DRAWING REVISION NOTES:
SHEET 2 OF SDP-99-054 (COLUMBIA GATEWAY) HAS BEEN REVISED TO PRESENT THE PROPOSED ENTRY & EMPLOYEE LOUNGE SPACE DESIGNS. THE PROVIDED LEGEND CLARIFIES THE SYMBOLS UTILIZED ON THE DEVELOPMENT PLAN. THE PLAN ILLUSTRATES THAT 11 TREES WILL BE REMOVED & 25 WILL BE PLANTED. THE EXISTING BOLLARDS WILL BE REMOVED & 16 NEW BOLLARDS WILL BE INSTALLED. A PAVILION, RETAINING WALL & HARDSCAPE WILL BE ADDED TO THE EMPLOYEE LOUNGE WHILE AREAS OF PLANTING WILL BE ADDED IN PLACE OF HARDSCAPE AT THE ENTRY AS WELL AS 3 FLAGPOLES & 12 POST LIGHTS.

SITE DEVELOPMENT PLAN
COLUMBIA GATEWAY
Parcels T-1, T-2, T-4 and T-5
Plat # 13402 thru 13404 & Plat No. 18716

SDP 99-54

SCALE	ZONING	G. L. W. File No.
1"=20'	M-1	98067
DATE	TAX MAP - GRID	SHEET
NOVEMBER 1998	43 1,2,7,8	7 OF 22

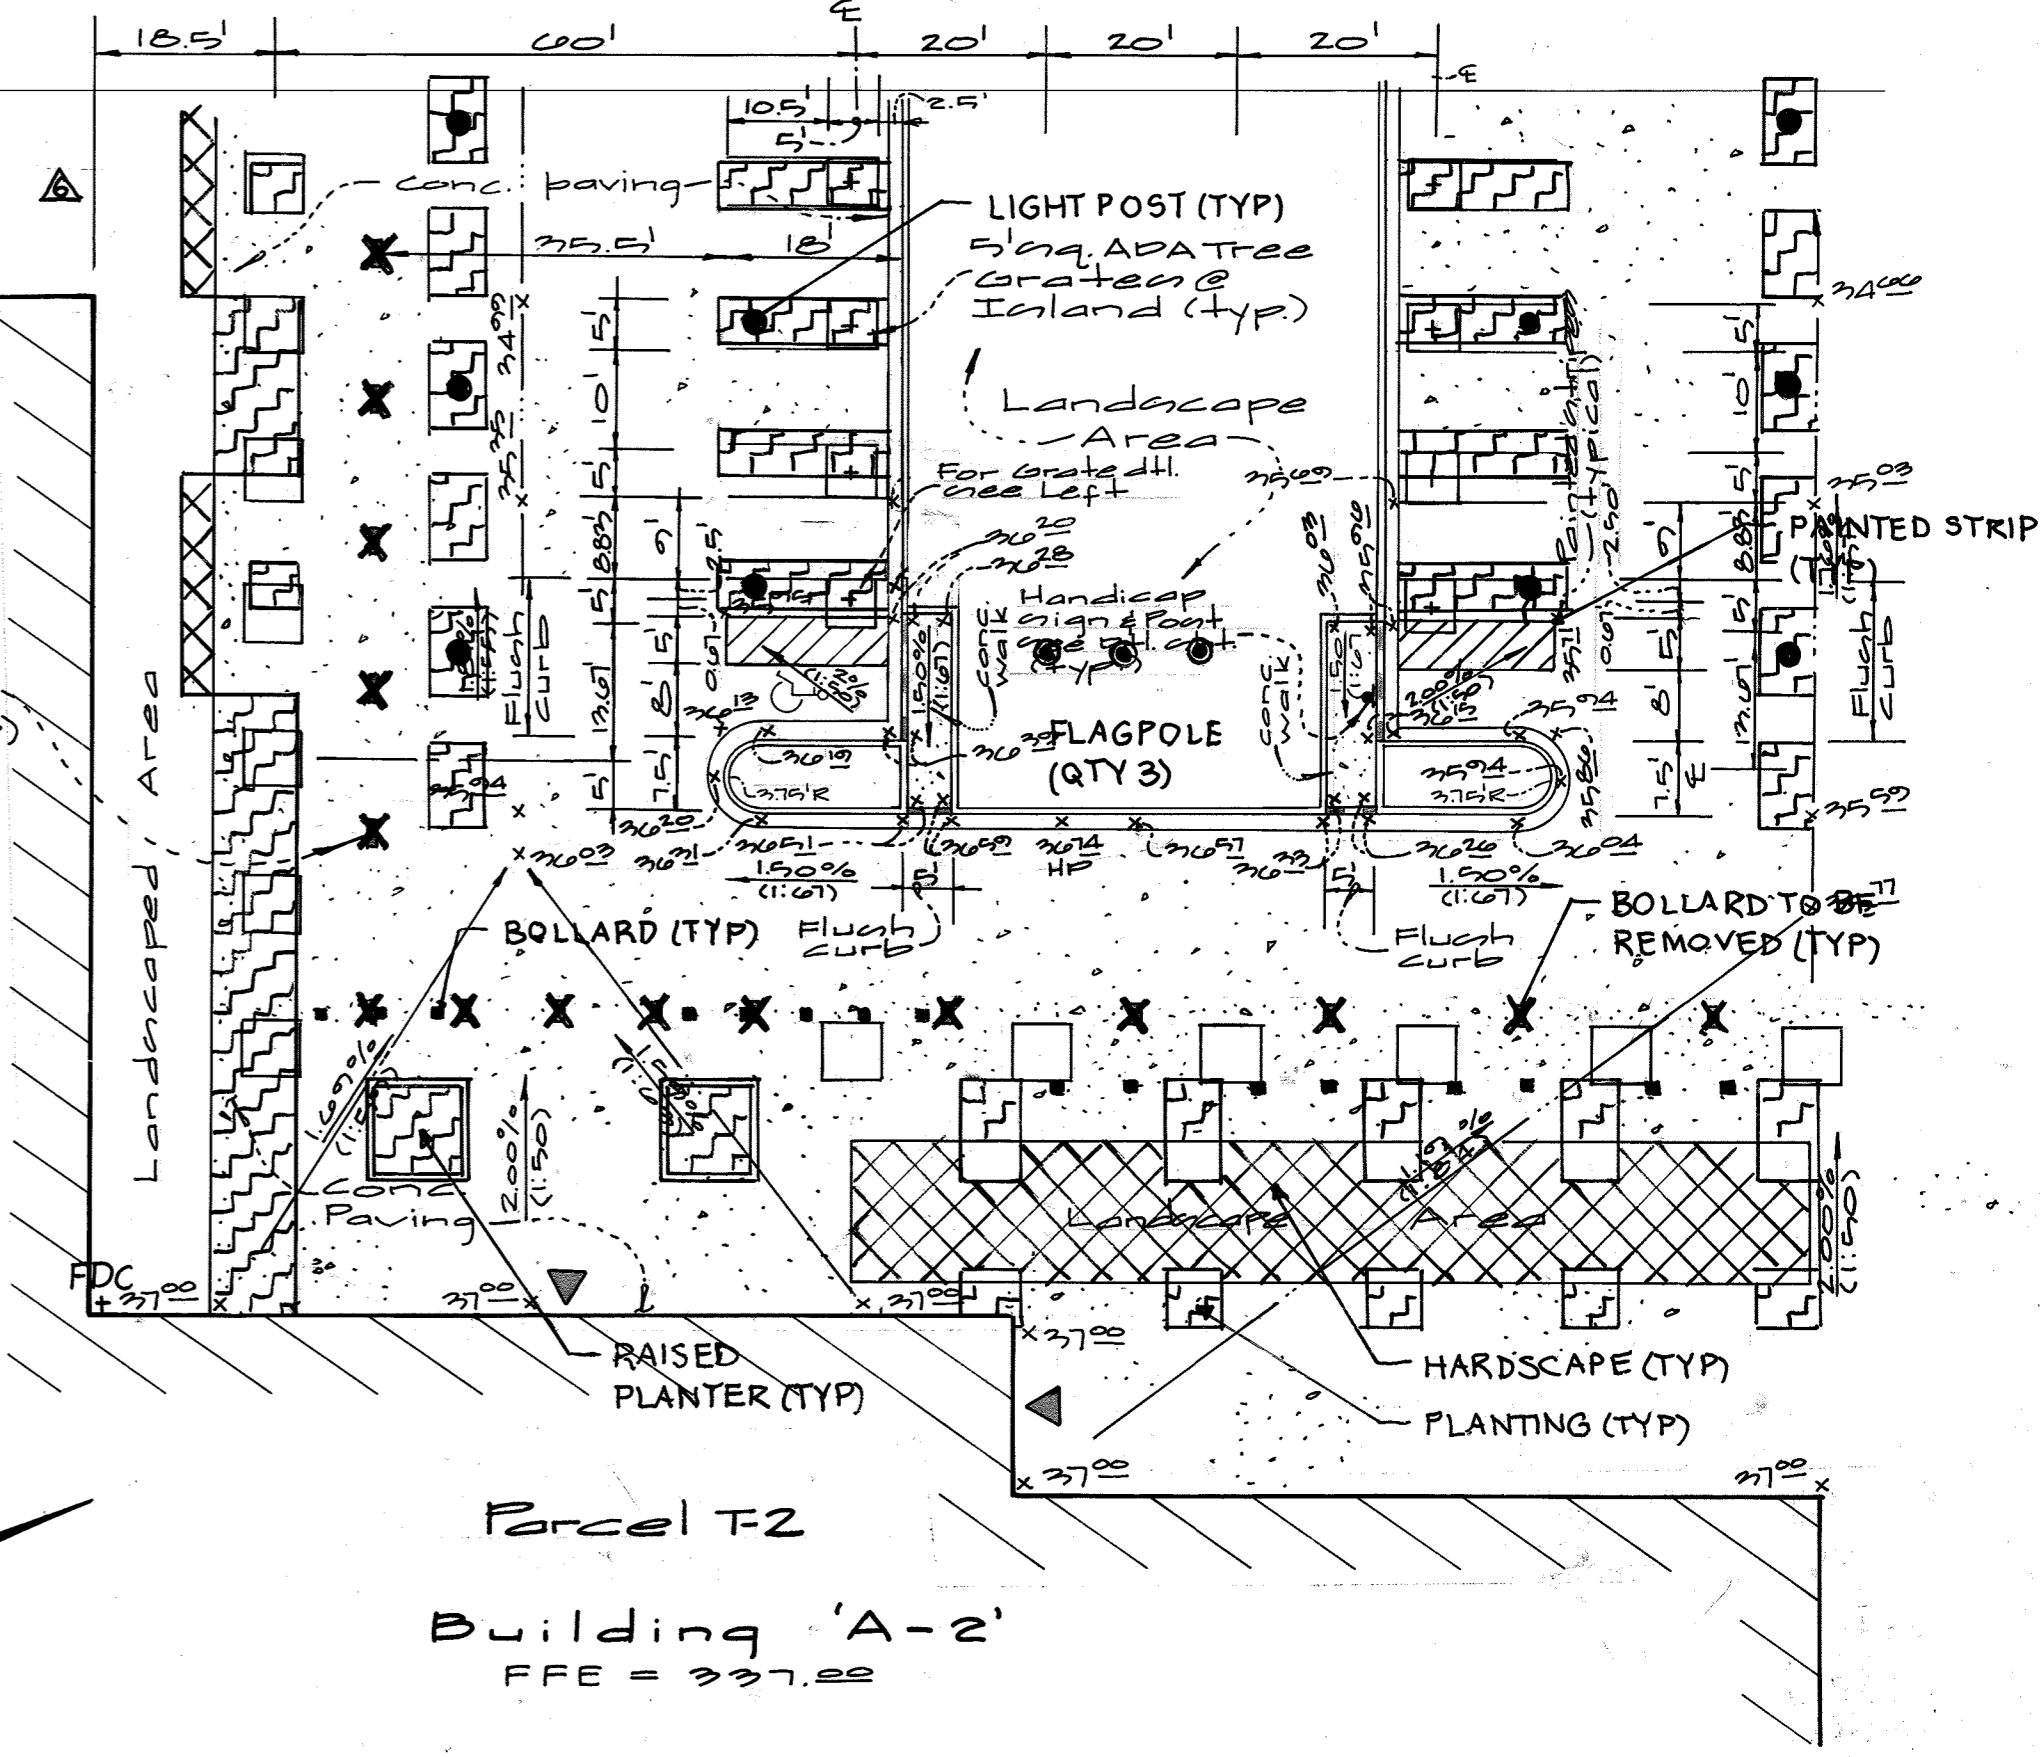
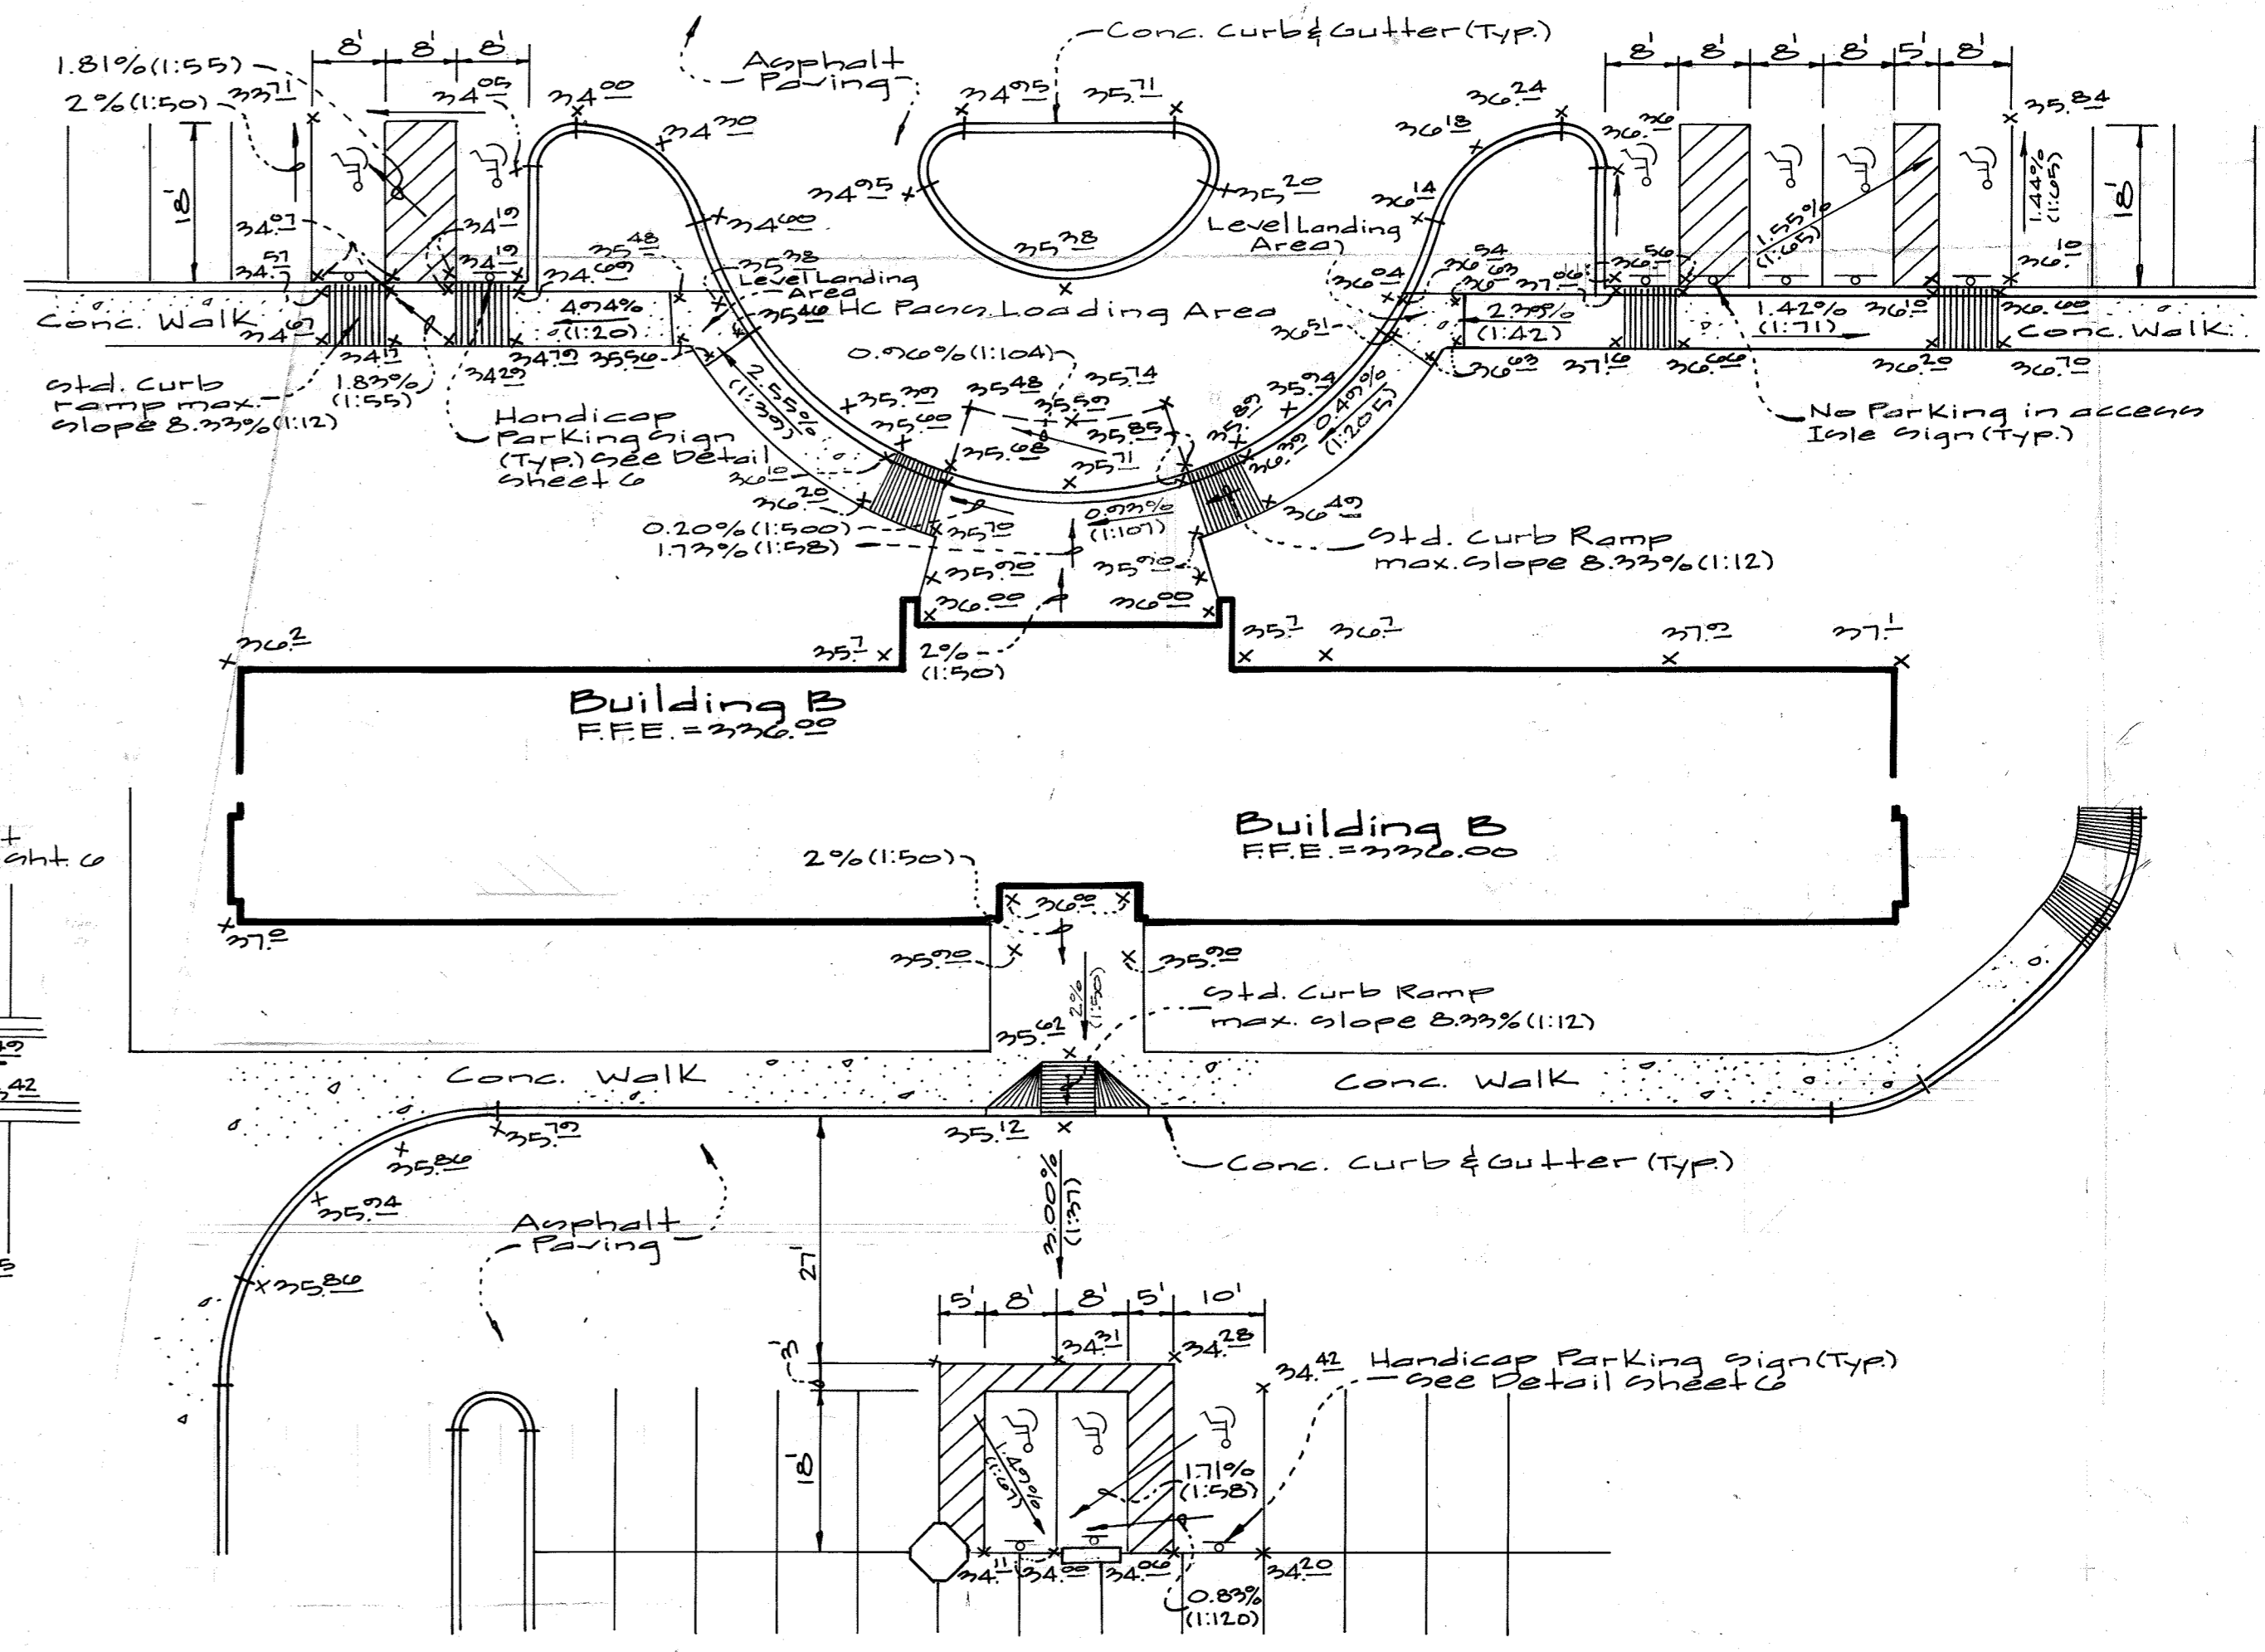
DRAWING REVISION NOTES:
SHEET 7 OF SDF-93-054 (COLUMBIA GATEWAY) HAS BEEN REVISED TO PRESENT THE PROPOSED ENTRY DESIGN. THE PROVIDED LEGEND CLARIFIES THE SYMBOLS UTILIZED ON THE HANDICAP ACCESSIBILITY DETAIL. THE DETAIL ILLUSTRATES THAT THE EXISTING BOLLARDS WILL BE REMOVED & 16 NEW BOLLARDS WILL BE INSTALLED. THERE WILL BE NO REDUCTION IN QUANTITY OF PARKING SPACES. 5' WIDE STRIPED ACCESS AISLES CONNECT TO THE EXISTING 5' WIDE ACCESSIBLE CONCRETE WALKS ON BOTH SIDES OF THE CENTRAL ISLAND.

LANDSCAPE & LIGHTING PLAN
COLUMBIA GATEWAY
 Parcels T-1, T-2, T-4 & T-5
 Plat No. 13402 thru 13404
 & Plat No. 18710
 HOWARD COUNTY, MARYLAND

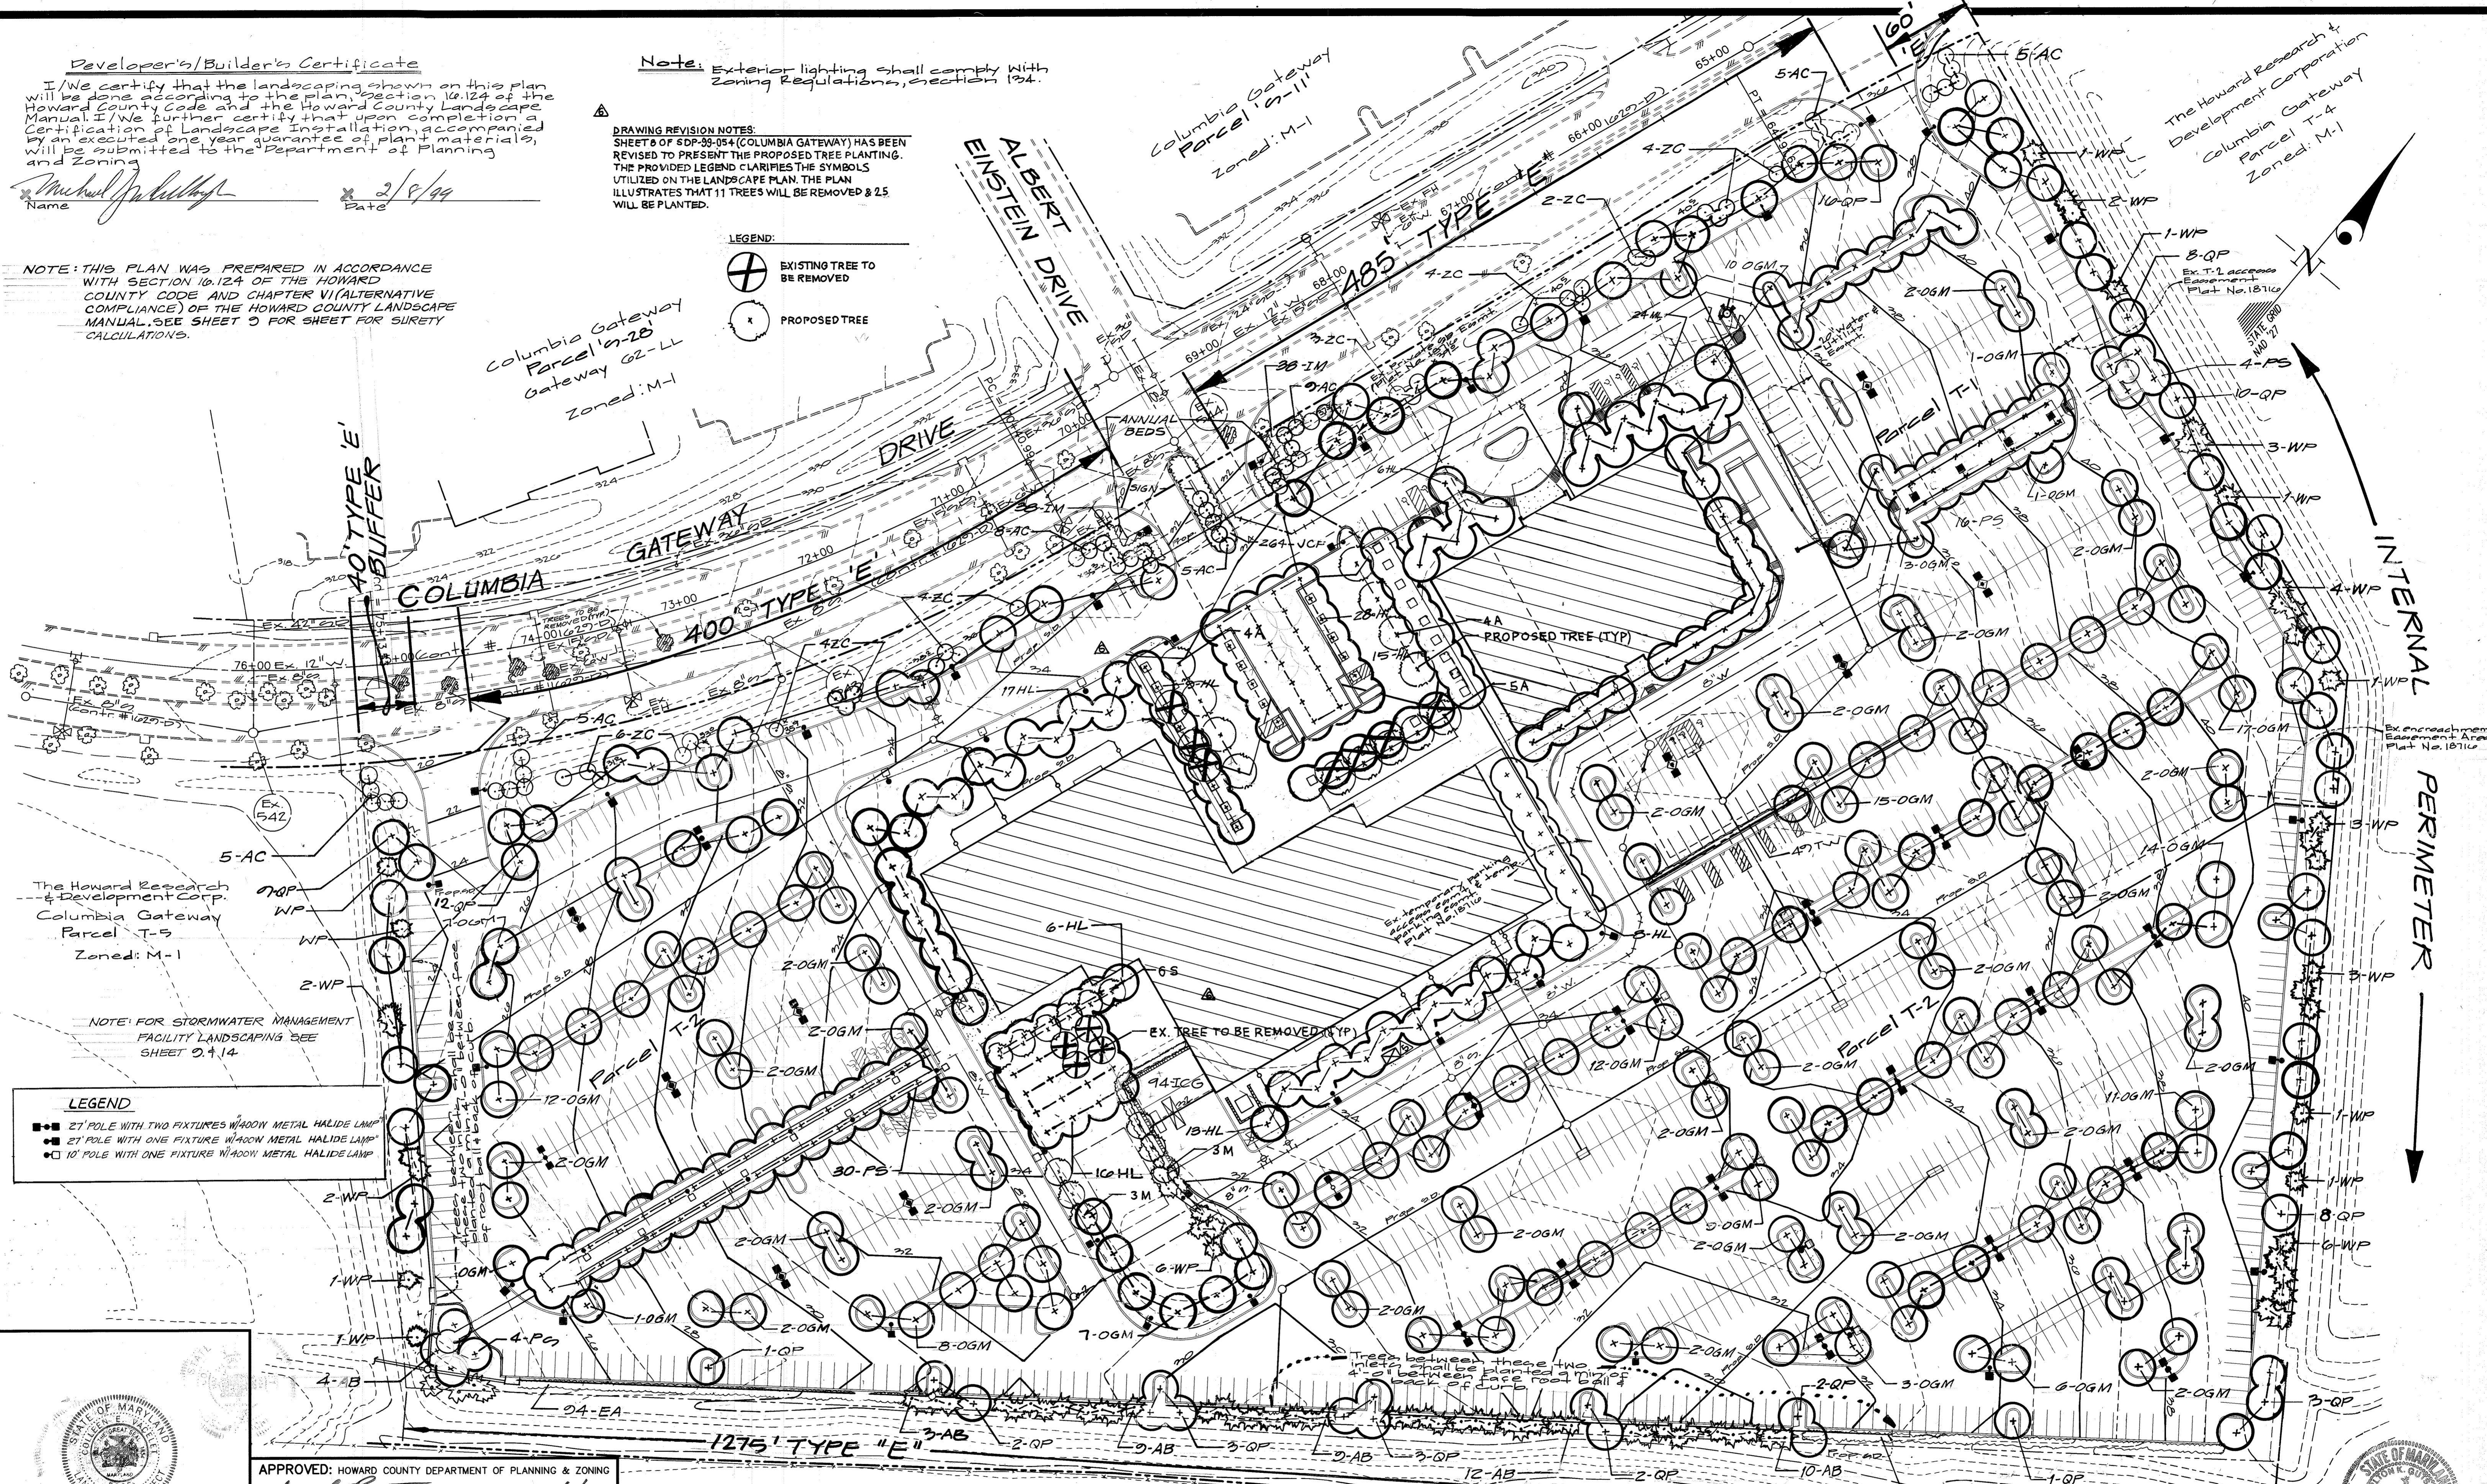
DRAWING REVISION NOTES:
SHEET 8 OF 8 DP-99-054 (COLUMBIA GATEWAY) HAS BEEN REVISED TO PRESENT THE PROPOSED TREE PLANTING. THE PROVIDED LEGEND CLARIFIES THE SYMBOLS UTILIZED ON THE LANDSCAPE PLAN. THE PLAN ILLUSTRATES THAT 11 TREES WILL BE REMOVED & 25 WILL BE PLANTED.
